AC Transit

Subject: Amendment to Workplan for Installation of Three Monitoring Wells
AC Transit, 1177 47th Street, Emeryville, CA

GROUNDWATER CONTOURS (MARCH 2001)

FIGURE 1

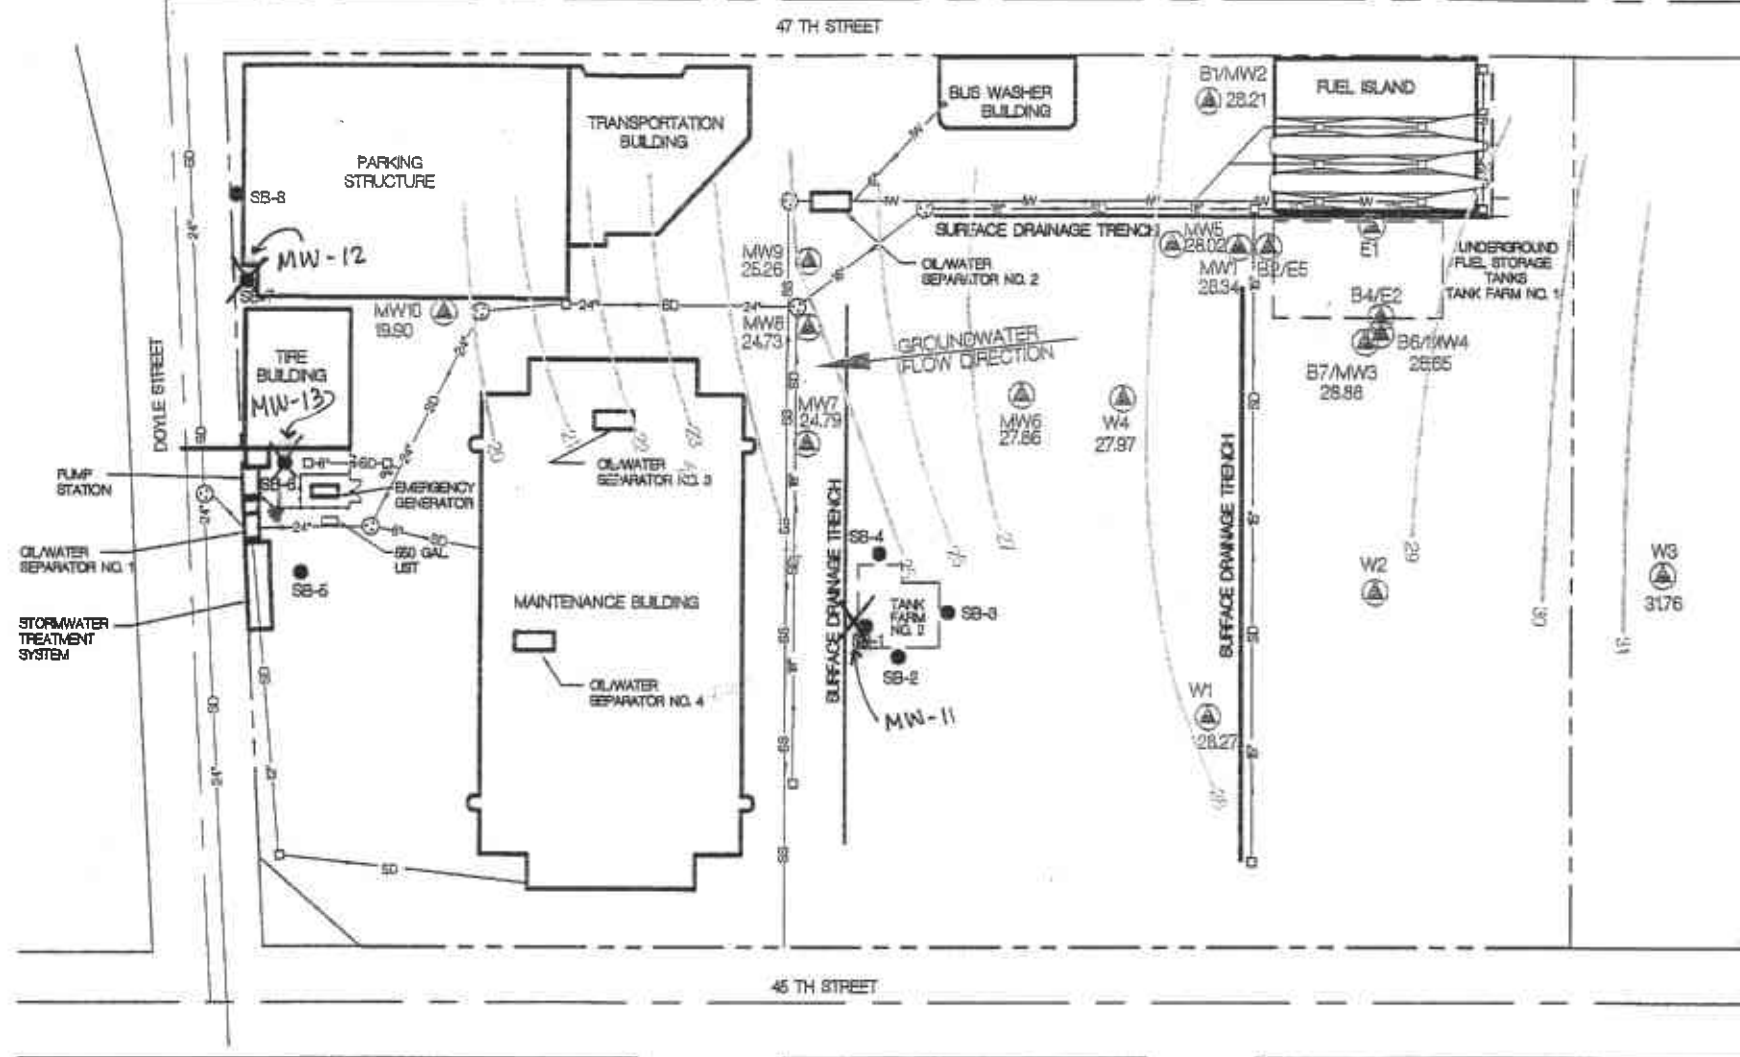
AC Transit plans to install three ground water monitoring wells during the third quarter of 2001 so sampling of these wells can be incorporated into the current monitoring program. These wells will be located near borings SB-1, SB-6, and SB-7 (depicted on attached figure). The construction details of these monitoring wells are the same as those contained on page 4 of the Workplan. Groundwater samples will be analyzed for total extractable petroleum hydrocarbons (TEPH) using EPA Method 8015 Modified and benzene, toluene, xylenes (BTEX), methyl tert-butyl ether (MTBE) and gasoline using EPA Method 8021B.

X MW-11 (Proposed) X MW-12 (Proposed) X MW-13 (Proposed)
